**RE: Responses to NRC's Requests for Additional Information Pertaining to HMC's License
Amendment Request to Change Radon Background Location from HMC 16 to HMC 10ff**

Response to Request for Additional Information (RAI)

License amendment request to change the background monitoring location for radon-222 in air at the Grants Reclamation Project.

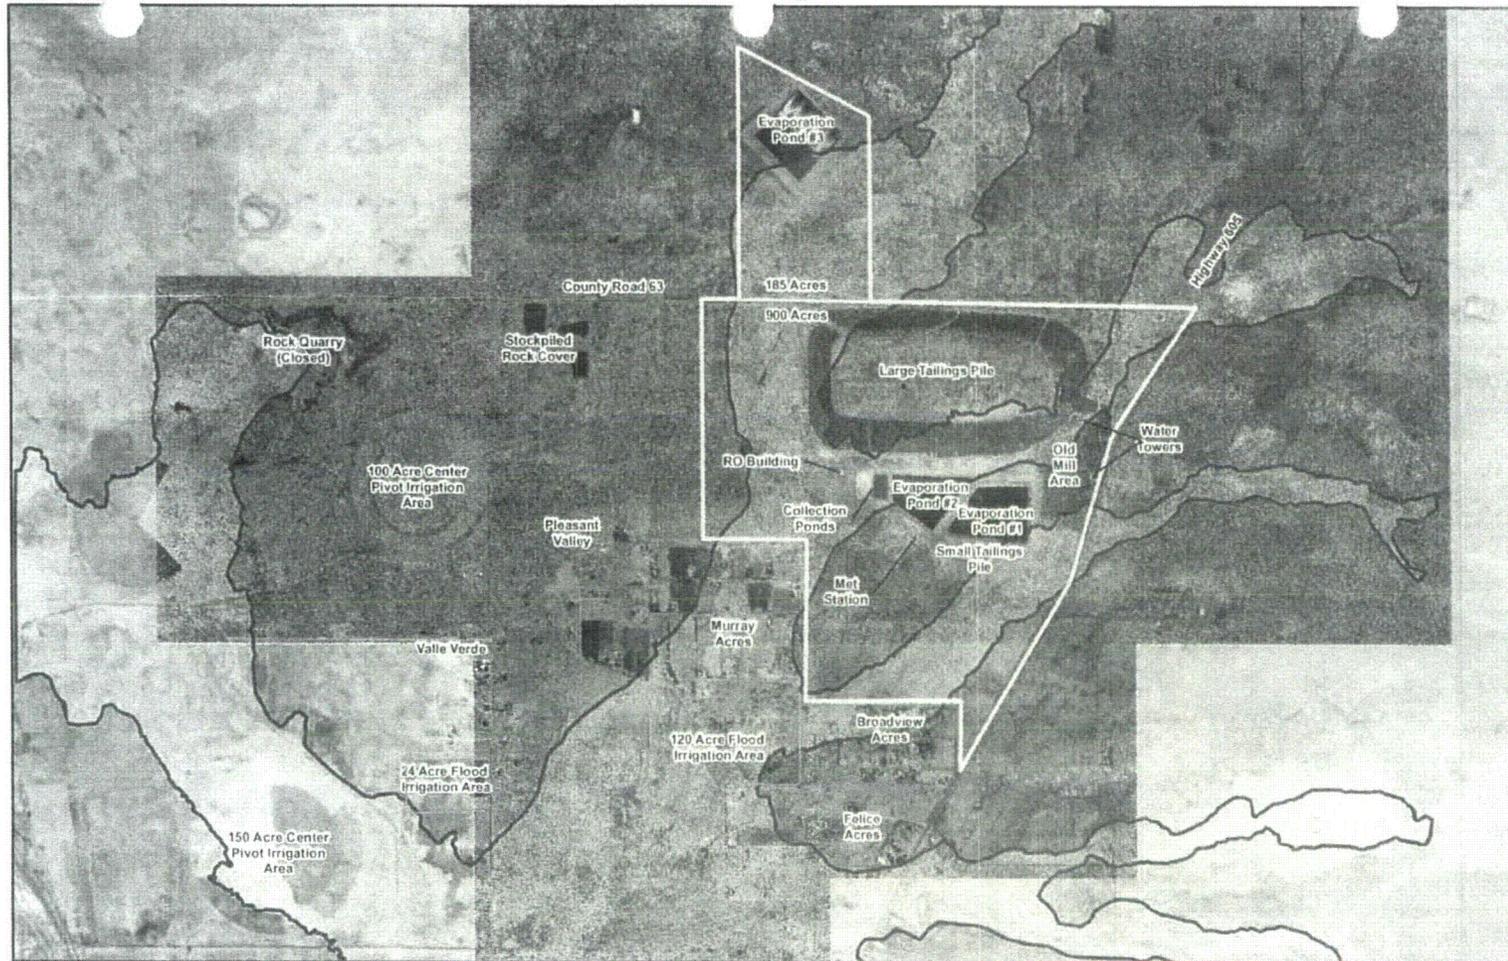
RAI #	Section(s)	Page #	RAI	Response
7	General	NA	Provide additional information explaining why sampling location HMC-16 is cross gradient of radon sources and why its location up gradient of the site affects its ability to be representative of background conditions at Homestake.	Figure 2-3 shows the location of HMC-16 relative to important drainages leading into the site. HMC-16 is located on a topographical high outside and west of the “Northwest Drainage” The drainage line near HMC-16 runs from the northwest, then turns east, and finally runs northeast prior to merging with the main “Northwest Drainage” line. If this location was upgradient from the site, the drainage line would run from the northwest to the southeast until it merged with the main drainage line just north of the site. For these reasons, we described HMC-16 as being cross gradient, not up gradient from the site. The conceptual model predicts lower radon concentrations at HMC-16 due to its topographic position than the locations in the (topographically lower) main drainage area. It should be duly noted that actual measurements support the prediction of the conceptual model.
